B.G.A. TECHNICAL COMMITTEE

TECHNICAL NEWSHEET

TNS 5/6/84

SKETCH 1.

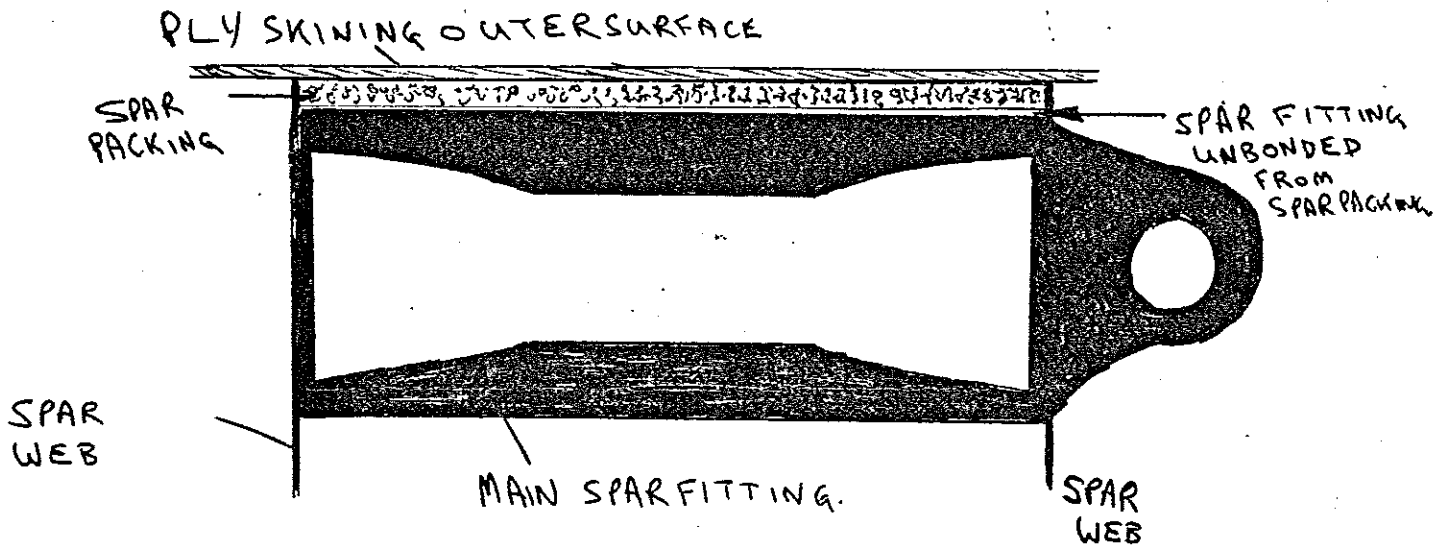
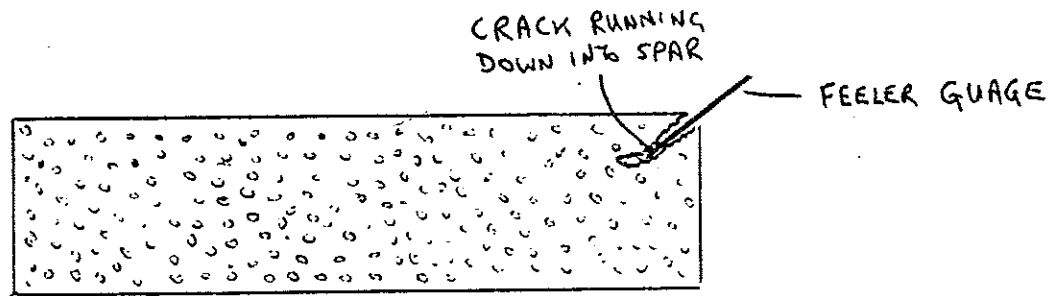
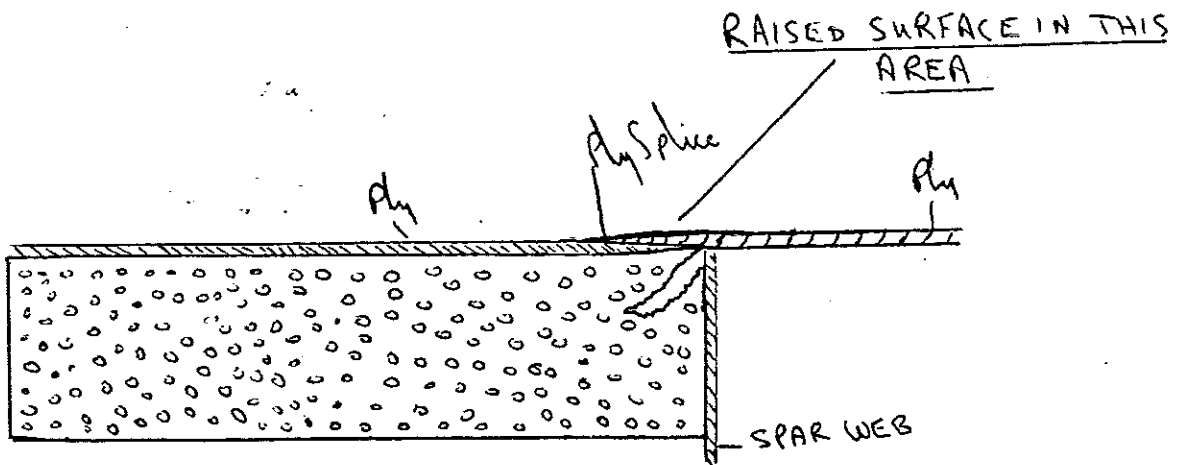
- 1.10. BOCIAN Spar Root Inspection Further to TNS 3/4/84 (item 1.11), a more specific diagram is attached herewith, kindly supplied by Lasham Gliding Society.

CRACKED TRIM SPRING

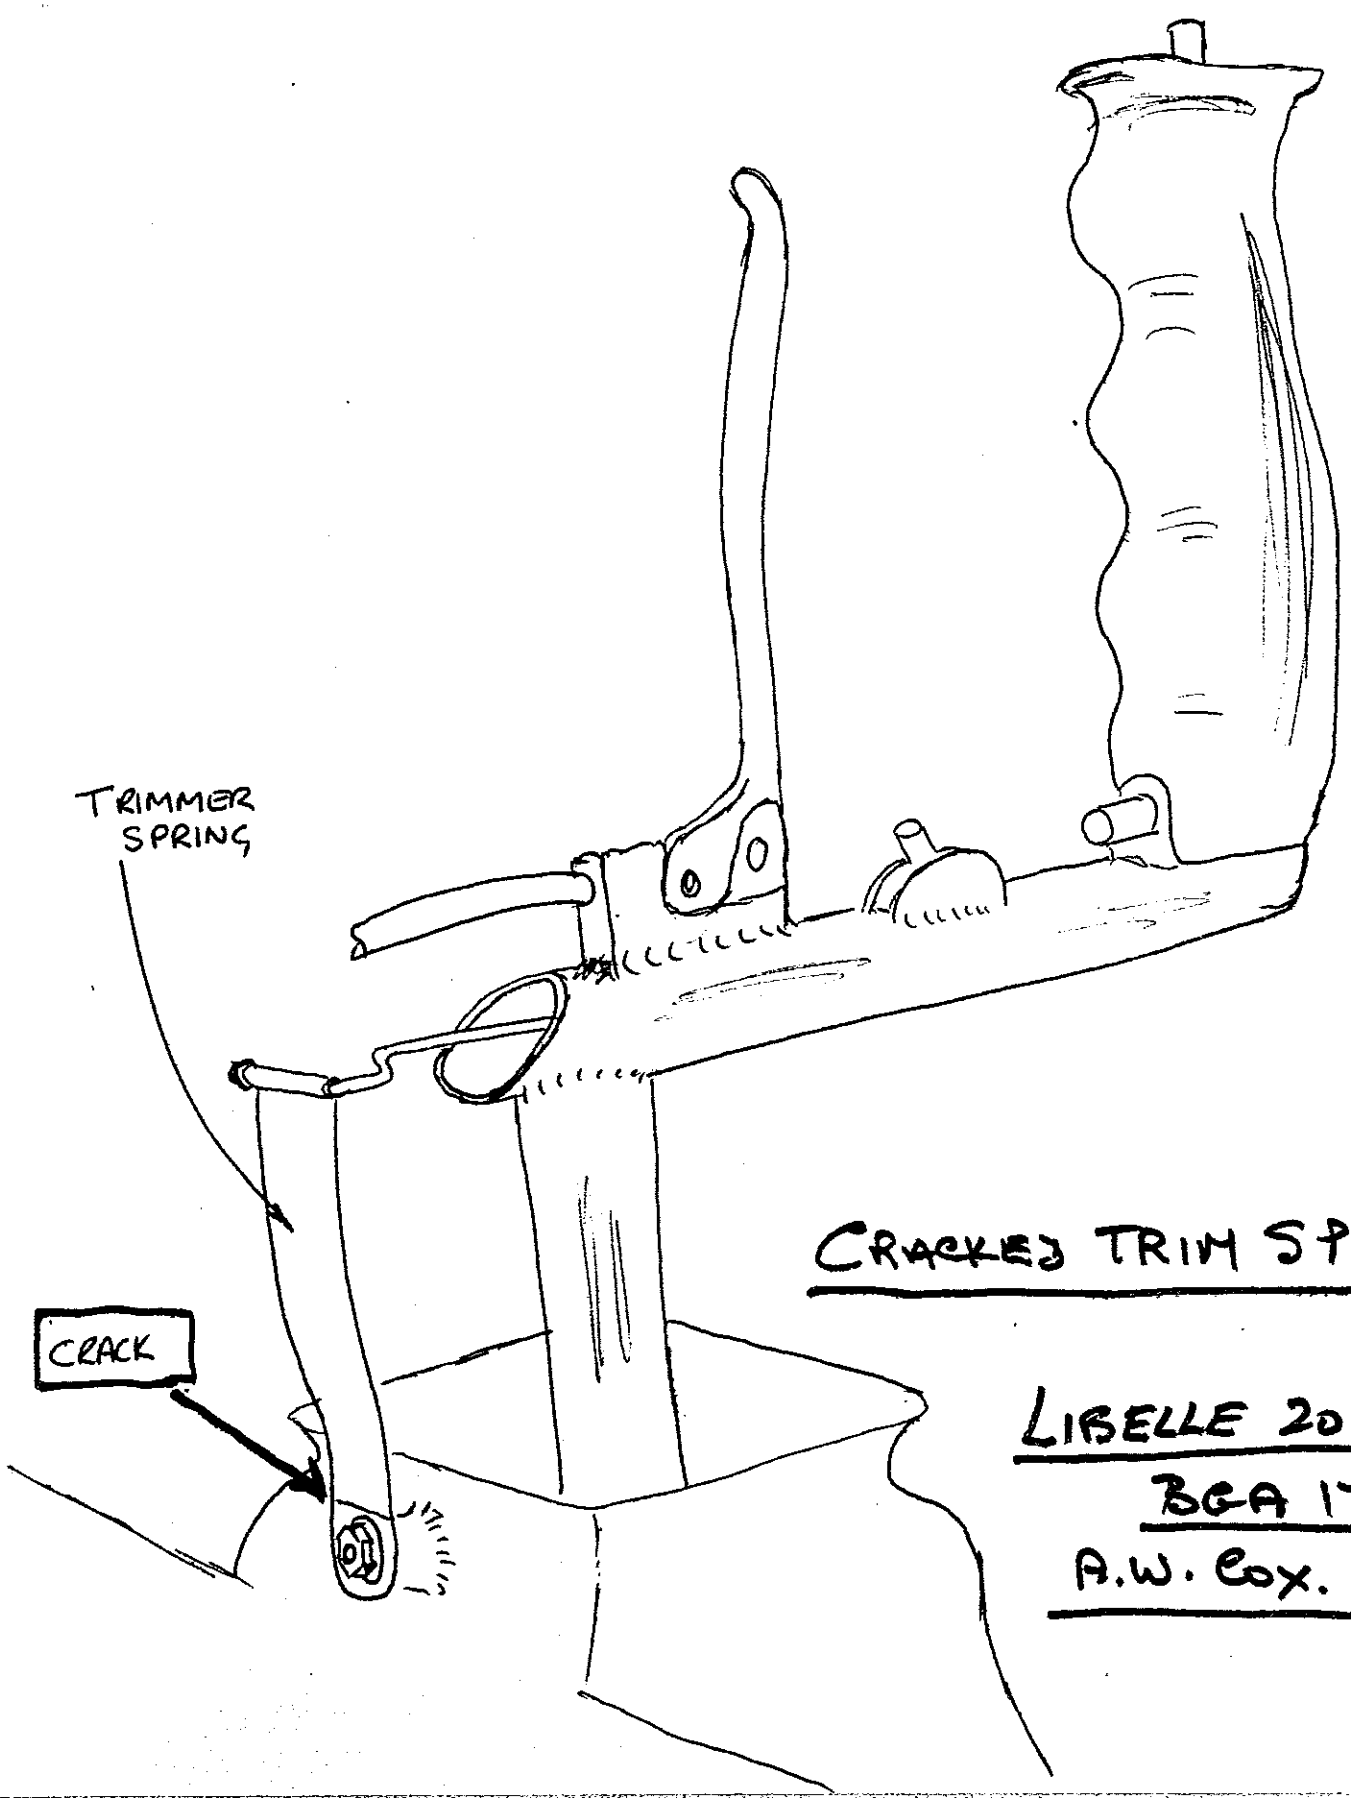
- 1.11. LIBELLE Trim Spring Cracked Sketch of this defect kindly supplied by A.W. Cox.
- 1.12. BLANIK Canopy Jettison found inoperative. Periodic jettison tests, and such maintenance as may be required, should be applied to all Blaniks a.s.a.p. (Reported by P. Wooller - Blackpool and Fylde G.C.).

ASW 19
Technical Note
No. 17

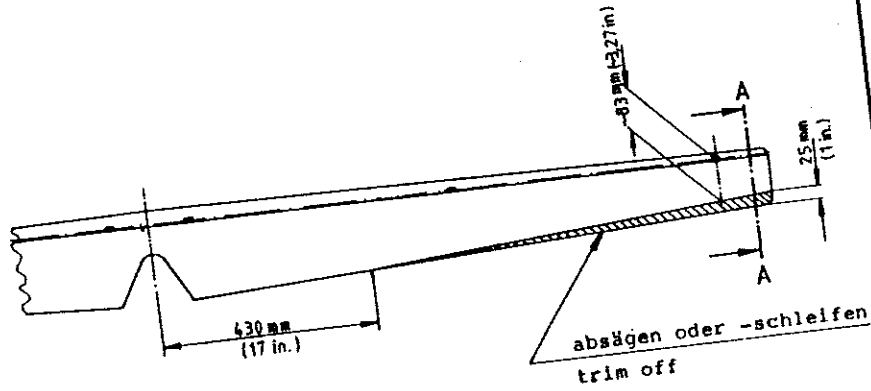
2. According to the sketch on sheet 4 of this TN, the elevator trailing edge is cut or ground off and reshaped on the lower surface.

The mass reduction by trimming and reshaping the trailing edge has the same effect as a much heavier mass balance in front of the elevator hingeline. Therefore, it is important to remove as much weight as possible from the trailing edge and to reduce a necessary glue joint to a minimum.

The glue joint must be at least 7 mm wide, but no more than 12 mm.

Verleimung, glue joint

min. 7 mm (0.28 in.)
max. 12 mm (0.47 in.)

Hinterkante verjüngen
reshape trailing edge

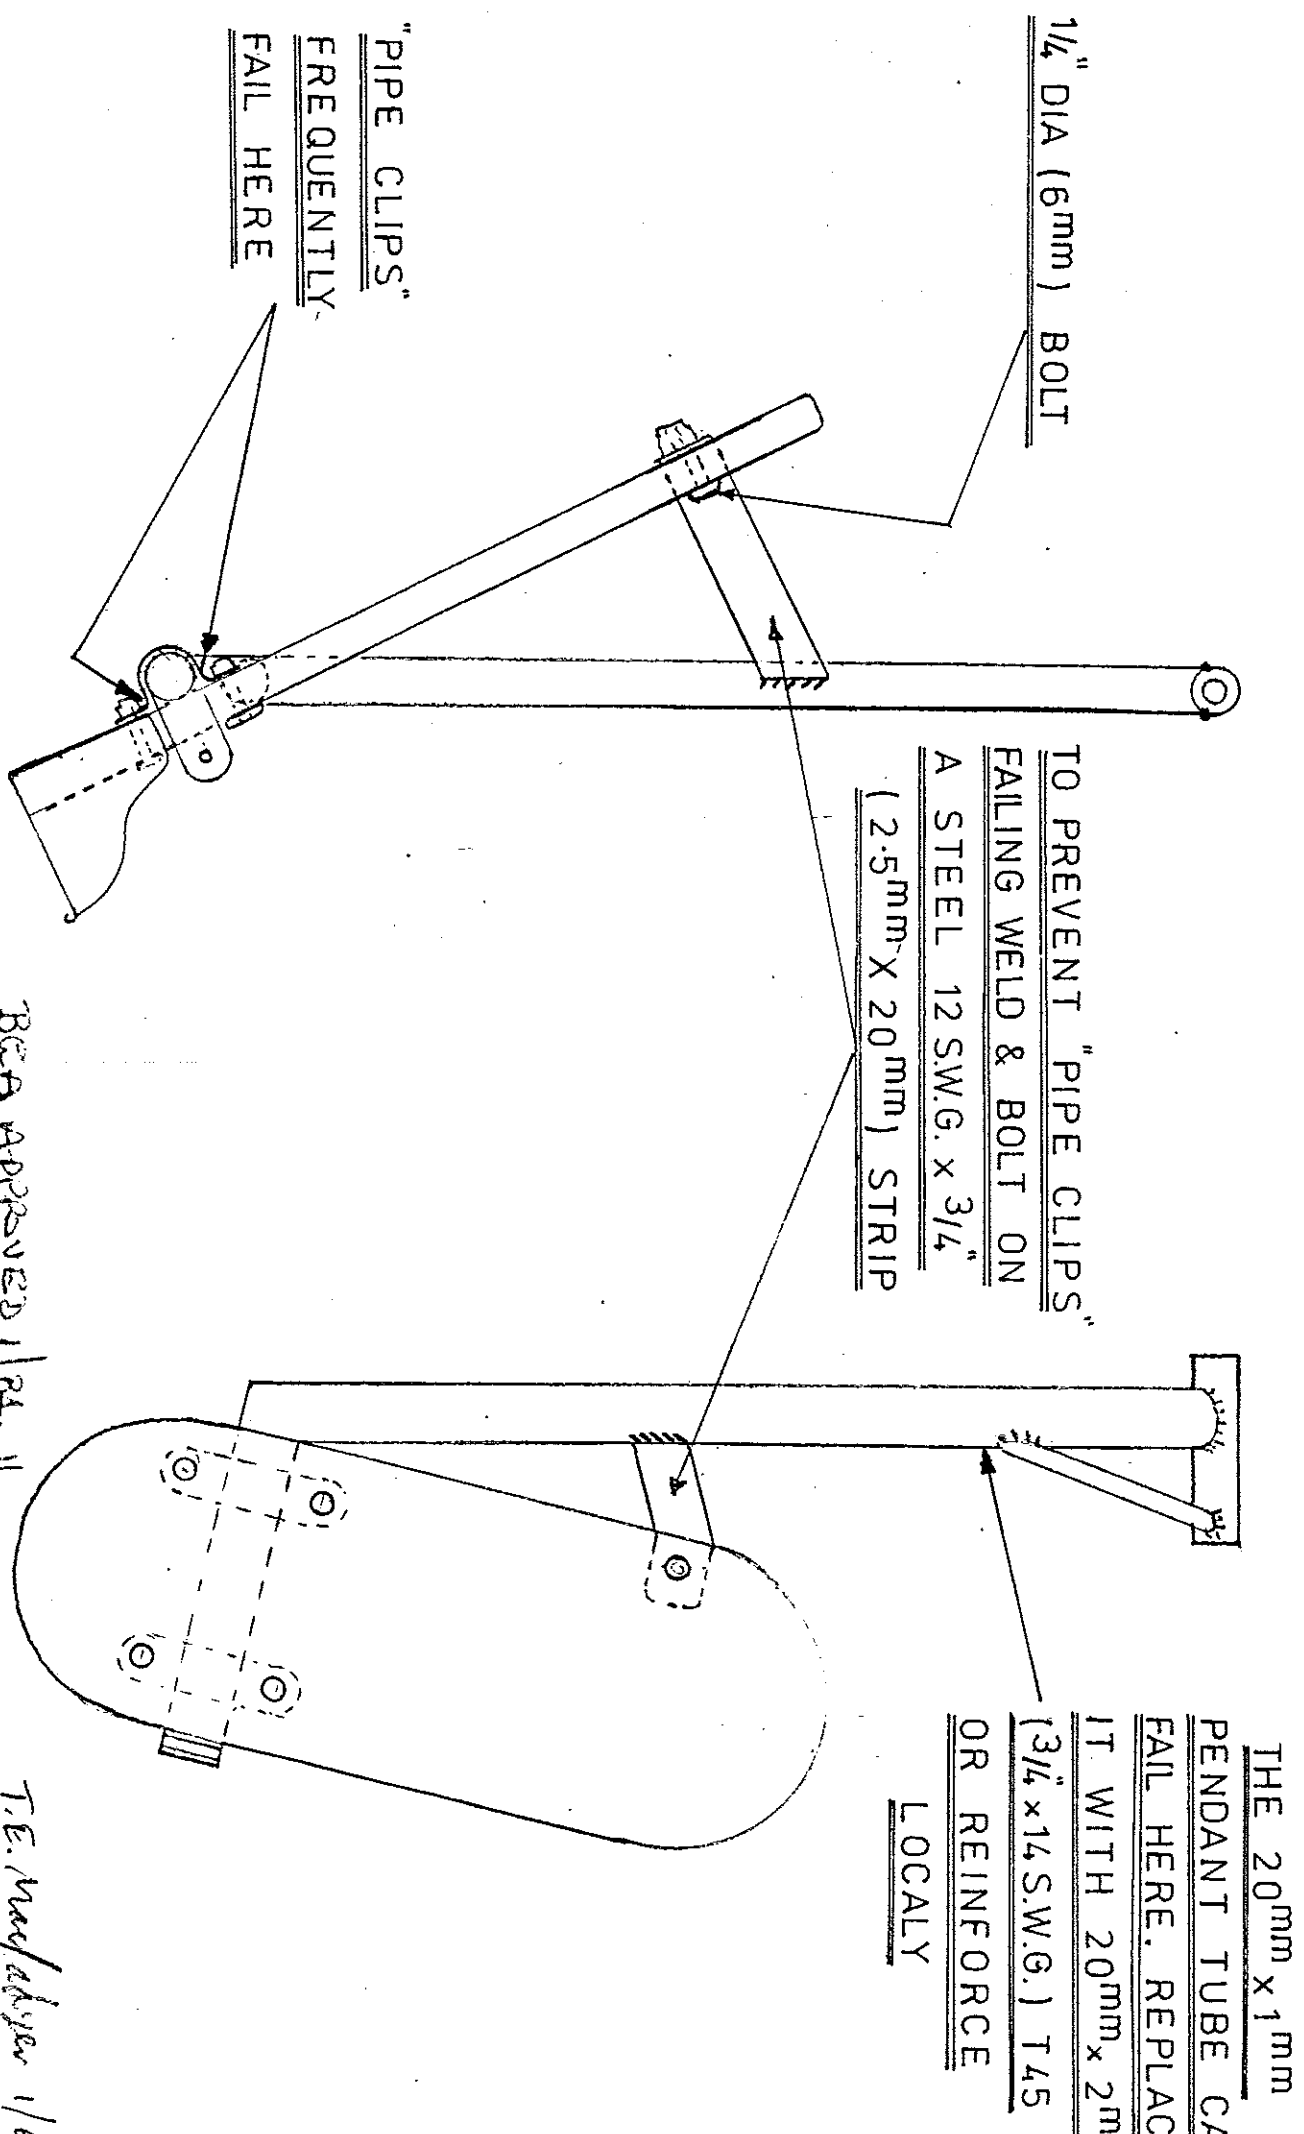
- 1.20 KA 2/KA 6/KA 7/KA 8 Cracks in Rudder Pedals (Re-enforcing modifications). Sketch attached herewith may be applied where defects are discovered by inspection (T.E. Macfadyen, Cotswold G.C.).

"PIPE CLIPS"
FREQUENTLY
FAIL HERE

THE 20mm x 1mm
PENDANT TUBE CA
FAIL HERE. REPLACE
IT WITH 20mm x 2mm
(3/4" x 14 S.W.G.) T45
OR REINFORCE
LOCALLY

TO PREVENT "PIPE CLIPS"
FAILING WELD & BOLT ON
A STEEL 12 S.W.G. x 3/4"
(2.5mm x 20mm) STRIP
